JUNE 20, 2017
BOARD OF COUNTY COMMISSIONERS
ORANGE COUNTY, FLORIDA
ADDENDUM NO. 3 / IFB Y17-768-CC
ORANGE COUNTY CORRECTIONS BOOKING AND RELEASE CENTER
ENERGY RECOVERY UNIT REPLACEMENT

BID OPENING DATE: JUNE 27, 2017

8 mechanical curb detail
A7.3.1

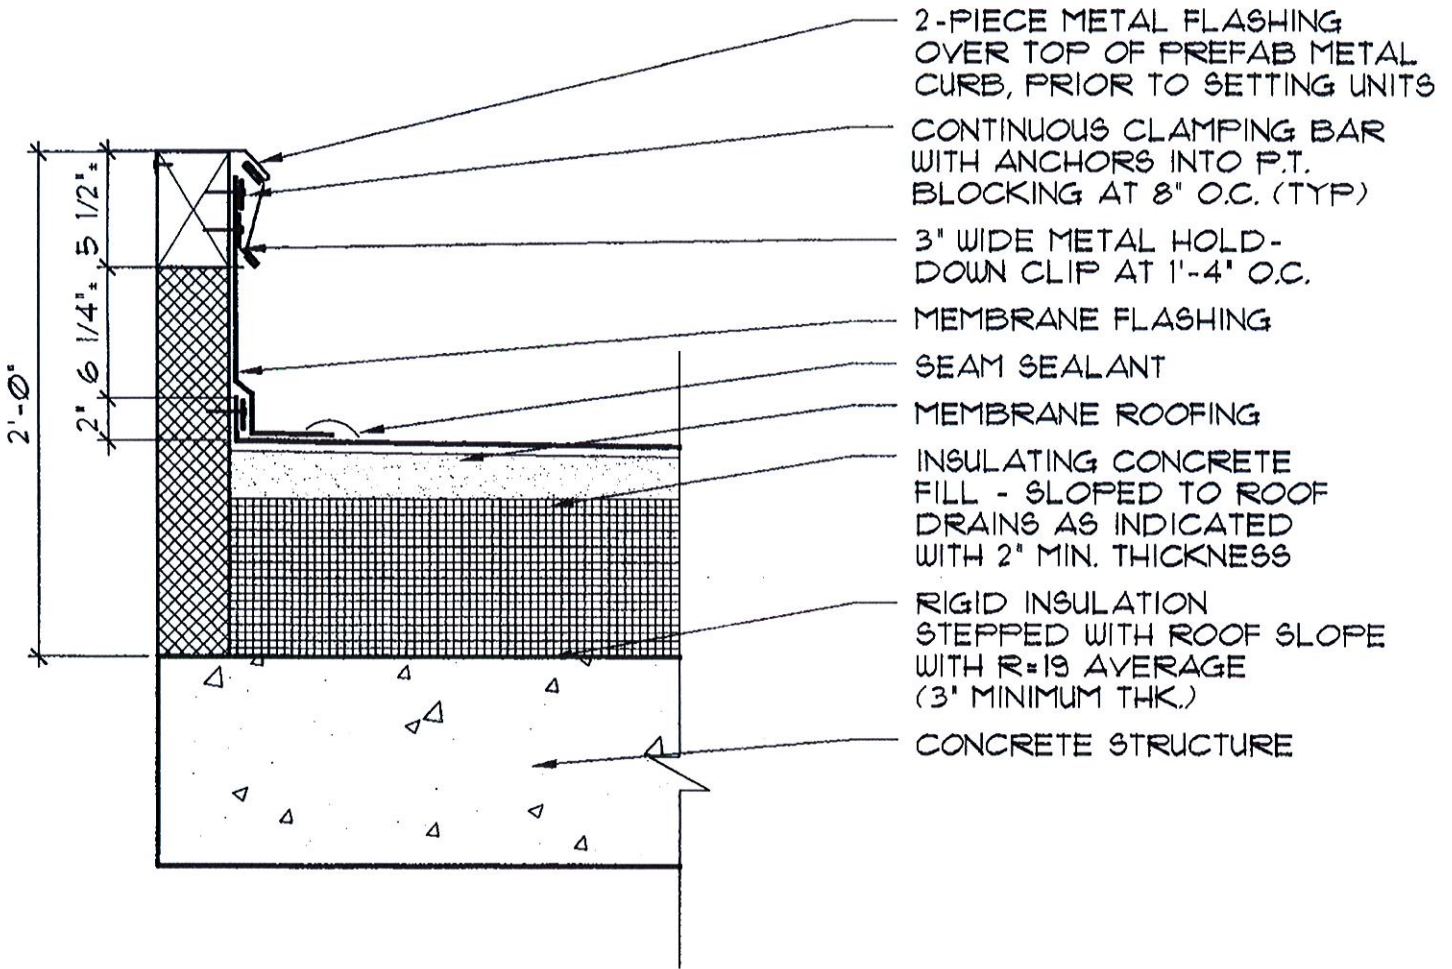
11. Question: Drawing M-102 indicates a new roof curb for each Energy Recovery Unit. Can you provide information about what type of roof insulation and material is required for insulating around new roof curbs?

Response: As-built drawings indicate that roof consists of insulating concrete fill-sloped to roof drains with 2-inch minimum thickness and rigid insulation with R-19 insulation average (3-inch

minimum thickness). Reference as-built detail 8 sheet A7.3.1 dated 3/17/2003 for make-up of roof. (See attached)

NOTE: PROVIDE PREFAB CURBS FOR ALL ROOF MOUNTED EQUIPMENT. CURB SHALL BE DESIGNED FOR THE SPECIFIC TYPE OF EQUIPMENT TO BE USED AND SHALL PROVIDE ALL NECESSARY CONNECTIONS FOR THE EQUIPMENT WITHIN THE CURBED AREA. NO CUTS OR PENETRATIONS OF CURB WILL BE PERMITTED UNLESS SPECIFICALLY SO NOTED BY THE MANUFACTURER.

CURT. MARK: DP-ELS-4C
 NOTE: COPPER BUS 1000A PSI

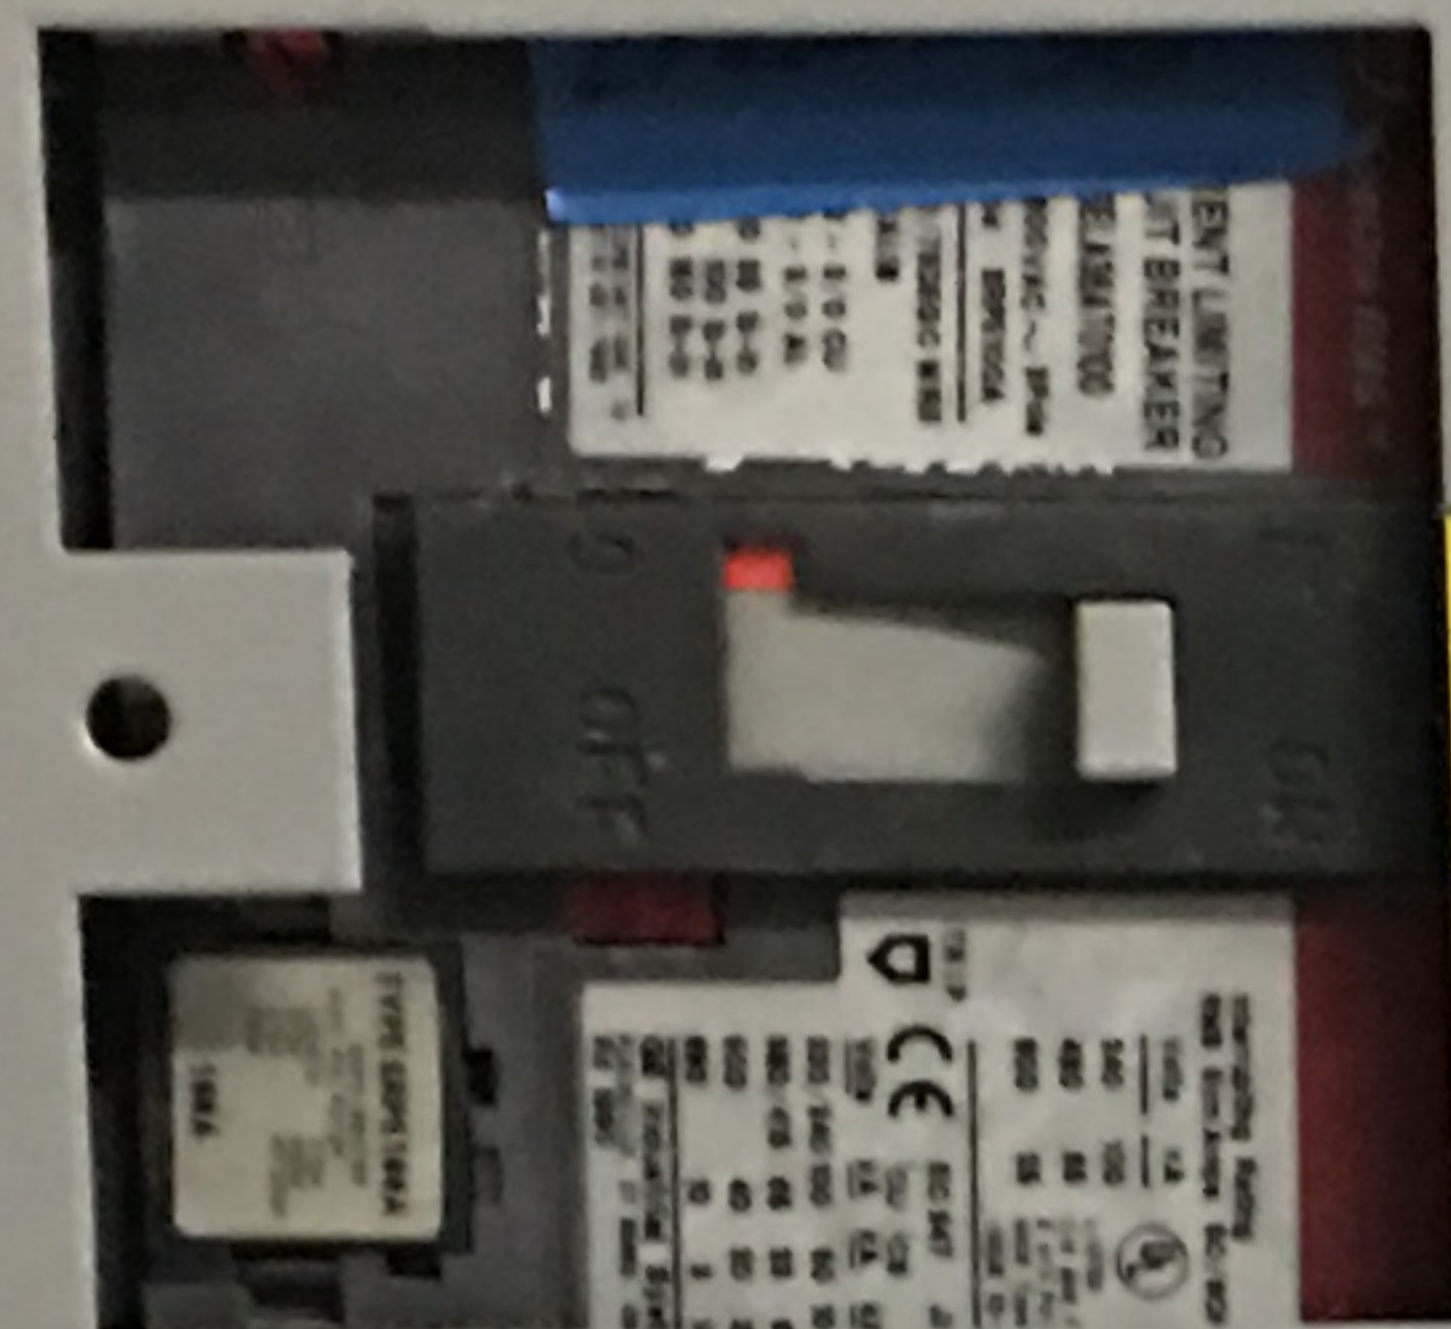
Response: Seal connections from new ERUs to existing exhaust and outdoor air ducts. Transitioning to existing ducts are necessary.
9. Question: The panel schedule E-001 call out Square D panels and the panels are General Electric (GE) panels. Can we get the correct information please?

12. Question: The plans call out that the panel DP-ELS-4C (the panel that we are adding the new breakers) is an NQOD panel. NQOD panels are 120/208 volt. We need to know the specific (name plate) style of the panel as well as the KAIC rating of the new breakers.
Response: Panelboard DP-ELS-4C is a 1200A, 480/277V, 3-Phase, 4-wire rated panel as noted on drawings. Panel manufacturer is a General Electric "Spectra Series" with an AIC of 42,000 Amps, not a type NOQD. New breakers shall match panel manufacturer, breaker type and AIC rating. See photos attached.
13. Question: Must the Prime Contractor for this project be a licensed General Contractor?
Answer: The contractor is responsible for ensuring all required permits are obtained. The majority of work performed on a particular project shall be within the scope of the Contractor's license.

Response: Panel board DP-ELS-4C is manufactured by General Electric (GE).
10. Question: Sheet E-101 Hex Note #1 reads Panel board DP-ELS-4C. As the existing power panel, it appears that MP-E4C is the existing power panel. Which is correct?
